CALIFORNIA COASTAL COMMISSION

REGULAR CALENDAR STAFF REPORT AND PRELIMINARY RECOMMENDATION

Application No.: 6-95-128

Description: Enhancement of Famosa Slough including installation of fencing, interpretive signage, trail improvements, removal of exotic vegetation, planting of native habitat, and replacement of hydraulic gates.

Pathway Control

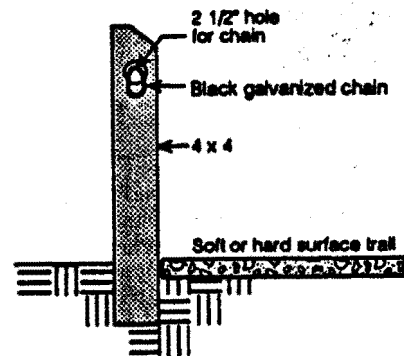
Fencing will also be installed adjacent to the proposed pathways to further control pedestrian access consisting of a chain and post fence. The average height of the proposed fence would not exceed a maximum of three

feet in height. The post would consist of a 4-inch diameter with a small hole for a black galvanized security chain. Although the FSEP describes in detail the sizes and composition of the proposed fencing, it does not include specific information as to where which types of fences will be installed. As such, the project has been conditioned (Special Condition No. 1) for final fence plans which document that no fencing will be installed in sensitive areas or result in adverse impacts to wetlands. In addition, the condition further requires that the fence plan be revised to indicate that the proposed wood post fence with black vinyl-coated chain link along West Point Loma Boulevard shall not exceed a height of four feet and that all chain link fencing be black vinyl-coated to reduce visibility.

Special Treatment Fence

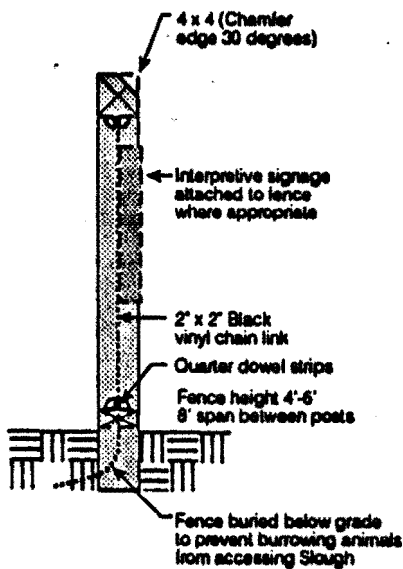
1. Final Plans/Fencing. Prior to the issuance of the coastal development permit, the applicant shall submit to the Executive Director for review and written approval, final fence plans. The fencing adjacent to West Point Loma Boulevard shall consist of wooden poles with black vinyl-coated chain link and shall not exceed a height of four feet. All other fencing around the perimeter of the Slough shall consist of a black vinyl-coated chain link fence with metal supports and poles not to exceed a height of six feet. Fencing for pathway control shall consist of a chain and post fence not to exceed three feet in height. Fencing shall be installed in accordance with the final fence plans. No fencing shall be permitted within any sensitive habitat areas or result in any fill, dredging, or other disruption of any wetlands.

However, because the section of fencing near West Point Loma Boulevard is highly visible from the public roadway, the Commission finds the maximum height permitted shall be four feet, as opposed to six feet, in order to protect public views toward the Slough. Furthermore, the primary access/entry way into the Slough on the east side of Famosa Boulevard, south of West Point Lomas Boulevard will remain open in nature without fencing, thus, preserving public views. In those remaining areas of the Slough where fencing will be installed, which are not as visible from public views, or in areas of "low visibility" as the City notes, generally, a standard 6-foot high galvanized chain link fence with metal supports and poles will be permitted. In all cases, such fencing will be located behind proposed pedestrian trails and will thus preserve the visual quality of the area. No impacts to existing sensitive vegetation will occur as a result of the proposed fence installation.

Sliding Flap-gate Detail

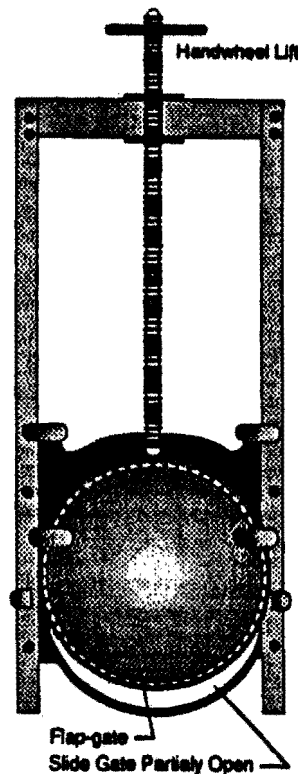
5. Final Plans for Hydraulic Gates. Prior to the issuance of the coastal development permit, the applicant shall submit to the Executive Director for review and written approval, final plans for the installation of the hydraulic gates. The final design shall assure that the installation of the headwall shall be constructed at an elevation above +12 feet NGVD to accommodate access for operational and maintenance purposes during periods of flooding. In addition, the plans shall indicate that the gates shall remain open at all times except in the event of flooding.

Manual side flap gates at the existing gate concrete headwall are proposed. The existing headwall modifications include raising the wall by approx. three to five vertical feet, providing an access catwalk, with fence and access gate. The water gates would be opened or closed using a manual crank on a stem riser which would project about three feet above the access walk. This would permit access to the gates as long as water levels remain below 12 feet. The Plan stipulates that the access gates could be raised even higher, if found necessary. One potential concern identified is that in the event flood levels in the river exceed the level of the proposed access walk and crank, the only way the gate could be opened would be by boat. For this reason, the Plan specifies that the operation/management system must ensure that this does not occur. As such, Special Condition No. 5 has been attached which requires submittal of final plans for the installation of the tidal gates which assures that they are constructed at an elevation above +12 ft. NGVD to accommodate access for operational and maintenance purposes during period of flooding. Furthermore, the plans shall specify that the gates shall remain open throughout the year except when flooding occurs.
